Access Compliance Report

Public Rights-of-Way

(Curb Ramps)

Intersection ID: N/A	Main Street: CORLISS_AV	Cross Street: ROGALLA_DR	Location: SE
ADA ID: 6B783DD5E7C0	Ramp Type: PerpDiag	Initial Pass/Fail: Fail	Overall Compliance: No
Severity Score: 22.5			
Codes/Mitigation Info/Possible Solution		Field Measurements/Component Compliance

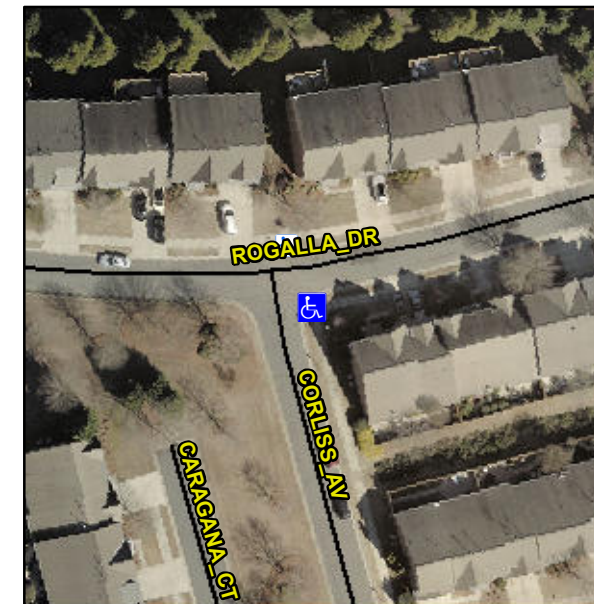
Not Found, R304.5.1, R304.2.2, R304.5.3

Compliance	Description	Data	Compliance	Description	Data
N/A	Ramp Length (in)	107.0	No	Ramp Slope (%)	8.7
No	Ramp Width (in)	37.0	No	Ramp XSlope (%)	4.2
N/A	Flare Type LT	N/A	N/A	Flare Type RT	N/A
N/A	Flare Slope LT (%)	N/A	N/A	Flare Slope RT (%)	N/A
N/A	Flare Traversable LT?	N/A	N/A	Flare Traversable RT?	N/A
N/A	Landing Length (in)	N/A	N/A	DWS Provided?	N/A
N/A	Landing Width (in)	N/A	N/A	DWS Contrast?	N/A
N/A	Landing Slope (%)	N/A	N/A	DWS Length (in)	N/A
N/A	Landing X Slope (%)	N/A	N/A	DWS Full Width?	N/A
N/A	Landing Curb? (Y/N)	N/A	N/A	DWS Offset (in)	N/A
N/A	Shared Landing?	N/A			
N/A	Gutter Ponding?	N/A	N/A	Gutter Slope (%)	N/A
N/A	Gutter Lip Ht (in)	N/A	N/A	Gutter X Slope (%)	N/A
N/A	Painted X Walk1?	No	N/A	Painted X Walk2?	No
	X Walk 1 Direction	To N		X Walk 2 Direction	To W
N/A	X Walk 1 Width (in)	N/A	N/A	X Walk 2 Width (in)	N/A
	X Walk 1 Slope (%)	0.7		X Walk 2 Slope (%)	2.8
	X Walk 1 X Slope (%)	1.1		X Walk 2 X Slope (%)	0.9

Remove & Replace Curb Ramp With Two New Directional Ramps or Equivalent.
